Re: 2nd Response to Comments

Tier III Permit Modification

Muskogee Community Recycling and Disposal Facility – Permit No. 3551020

ONRA 364 FYDANSION 2023 APPENDIY F.F.-1-3 CW PECUIPCES & HSACE MAD dwg innean 123

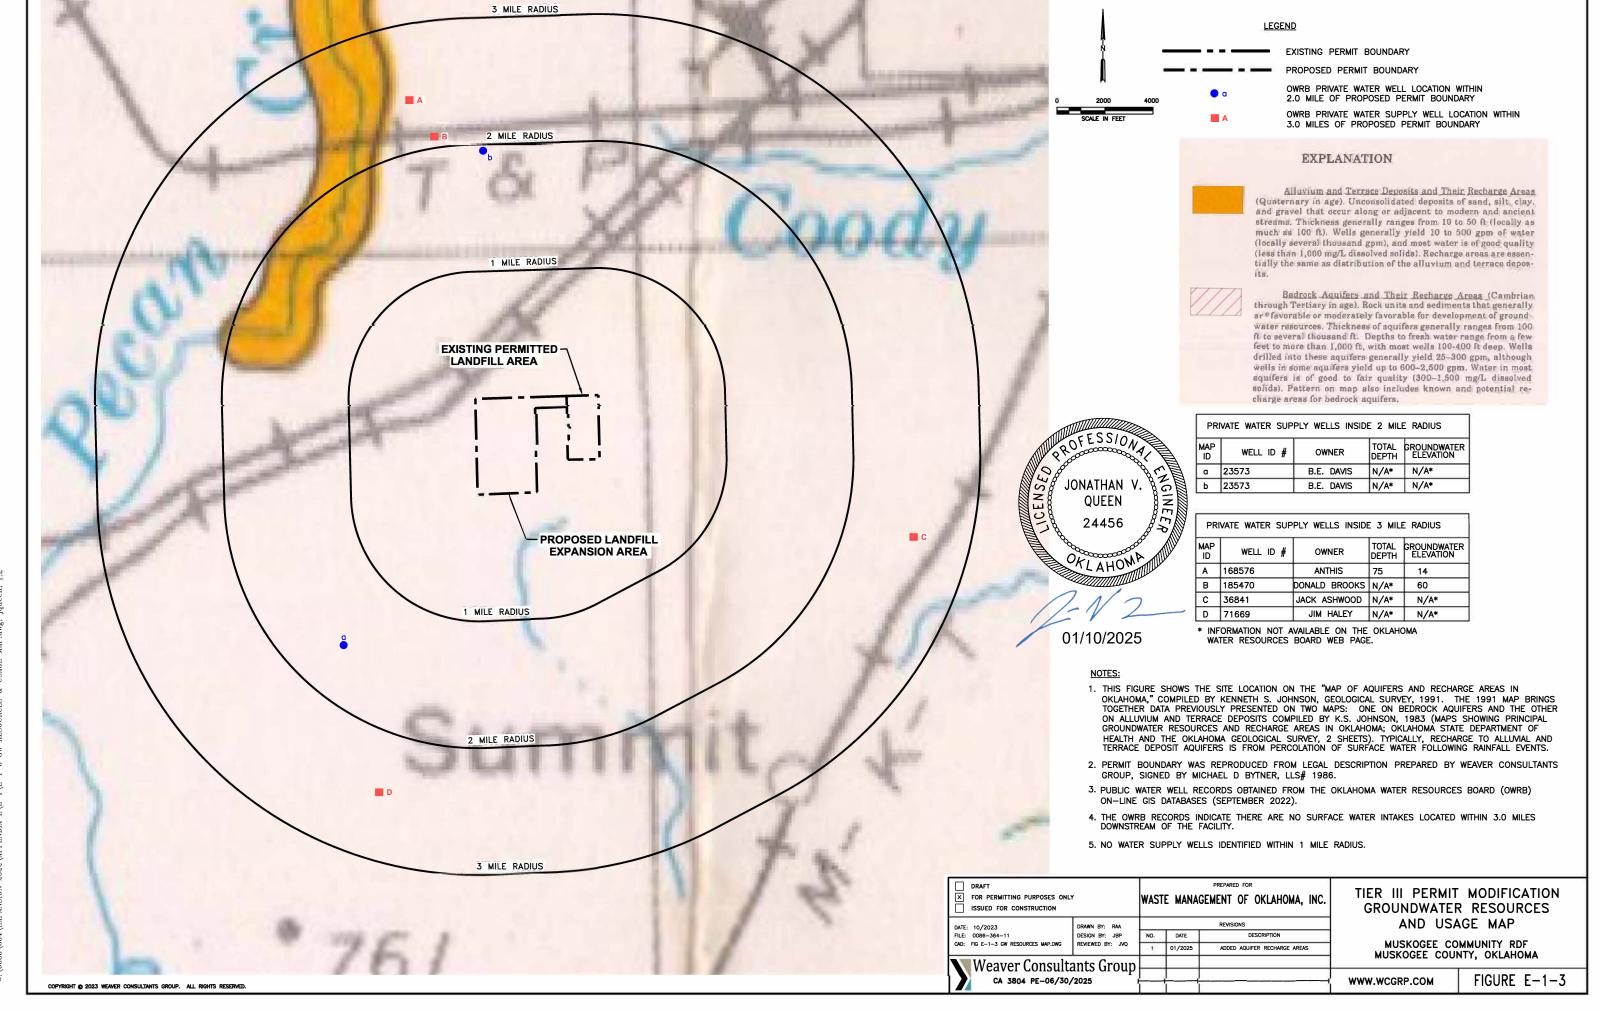
a. Groundwater Resources and Usage Map – The Response states that the Groundwater Resource and Usage Map (Figure E-1-3) in Volume 2A of the Application was updated to depict the recharge and discharge areas within a three-mile radius of the expansion area; however, the revised map was not attached to the Response. In accordance with OAC 252:515-3-72(b)(3), please revise Figure E-1-3 to show recharge and discharge areas within a three- mile radius of the proposed site boundary.

The base map on Figure E-1-3 Groundwater Resources and Usage Map has been updated to depict the recharge and discharge areas within a three-mile radius of the expansion.
